**RE: Landings at Jewell
Infrastructure Site Plan and Subdivision Plat Application
Case Numbers 2005-6048-06; 2022-3705-00
*Response to second review comments (Jan. 23, 2023)***

LANDINGS AT JEWELL INFRASTRUCTURE SITE PLAN

COVER SHEET
SHEET 1 OF 4
DECEMBER 16, 2022

SITE DATA

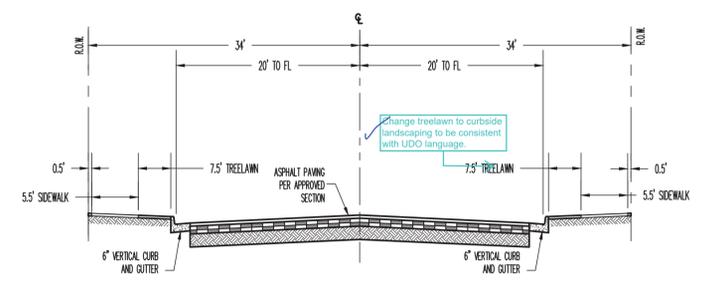
2D. Remove the parking line item from the data block.

3B. Repeat comment: Add percentages to the coverage areas in the site data block. The total needs to add to 100%.

Remove this parking line item.

Change from "Area" to "Height".

Add percentages to the each lot from its coverage area. The total needs to add to 100%.

Removed.

Added.

PRIVATE DRIVE TYPICAL SECTION

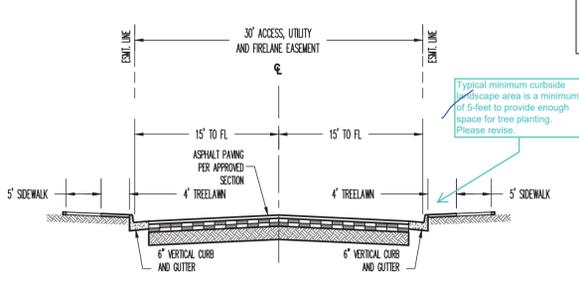
2B. Re-label the Private Drive section to "Public Access Typical Section" to match the easement title.

4A. Typical minimum curbside landscape area is a minimum of 5 feet to provide enough space for tree planting. Please revise the area shown outside of the private drive section.

Typical minimum curbside landscape area is a minimum of 5-feet to provide enough space for tree planting. Please revise.

This is labeled as a public access easement. Please revise the label to indicate "Public Access Typical Section".

Relabeled.

Revised.

RETAINING WALL DETAILS
N.T.S.

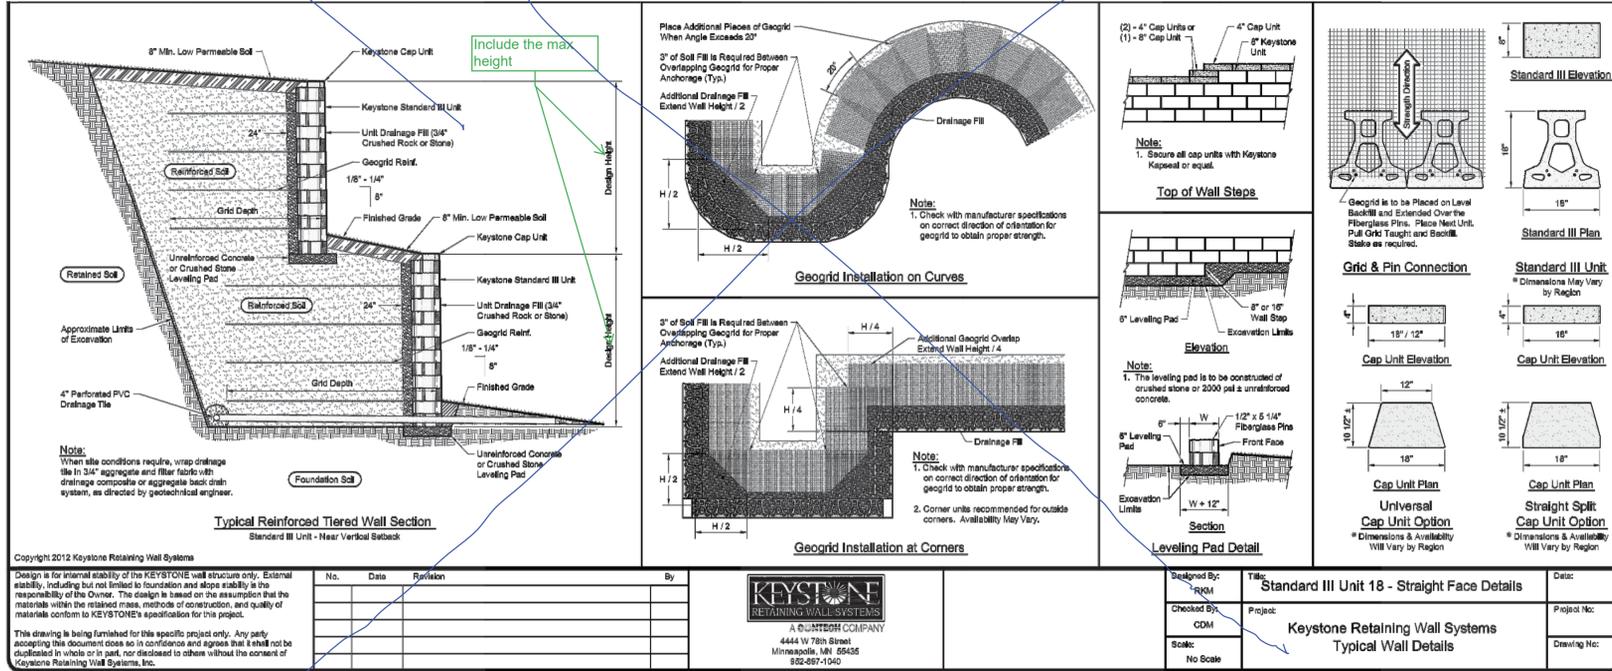
6F. There are more than two tiered walls in most locations. It is important for the City to understand what is being proposed: dimension the distance between the walls as well as the slope, and show the required railing. This is required for all walls over 30”. Refer to the Draft Roadway Manual update *anticipated to be adopted on 2/1/2023) in Section 4.02.4.06.

There are more than two tiered walls in most locations. It is important for the City to understand what is being proposed, dimension the distance between the walls as well as the slope, and show the required railing- required for ALL walls over 30". Refer to the Draft Roadway Manual Update (anticipated to be adopted 2/1/23) in Section 4.02.4.06

Wall removed.

RETAINING WALLS REMOVED

MONUMENT SIGN 'A' AND 'B' DETAIL
N.T.S.

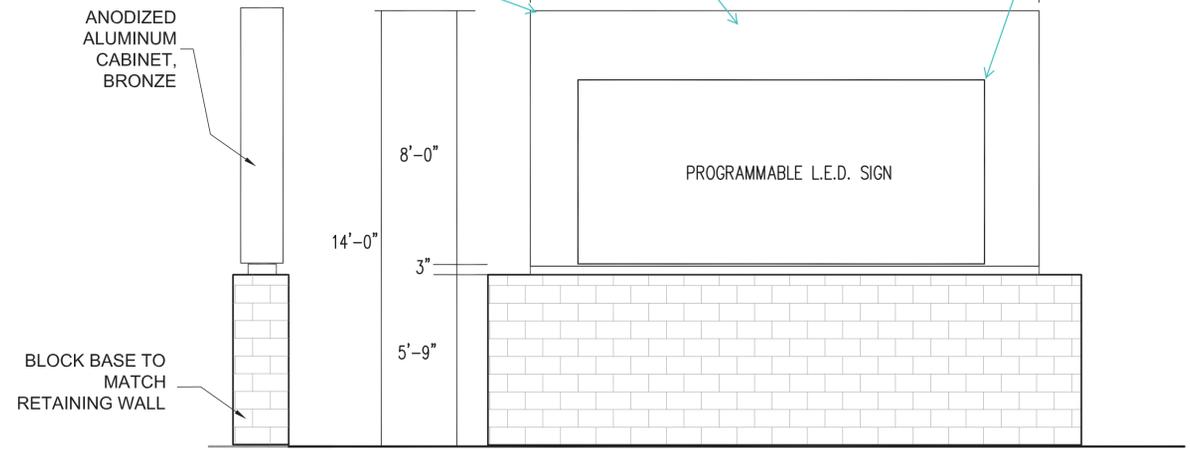
5D. Electronic message board area may not exceed 50% of the sign face. Please provide a detail showing the sign area and the programmable LED sign area to comply with this requirement.

5E. Per the Site Plan Data block, the sign has 100 s.f. of signage per sign face. Please indicate with a note or graphically if both sides of the sign are intended to include signage.

Please note that per the Landings at Jewell Master Plan (FDP) the Architectural Review Committee must review and approve all signage. Please coordinate with the ARC to finalize the approval of this sign prior to submitting building permits.

Per the Site Data block, this sign has 100 sq. ft. of signage per sign face. Please indicate with a note or graphically if both sides of this sign are intended to include signage.

Electronic message board area may not exceed 50% of the sign face. Please provide a detail showing the sign area and the programmable LED sign area to comply with this requirement.

add a note indicating that signage shall be subject to the Landings at Jewell ARC.

Note added.

Note added.

Note added.

Note added.
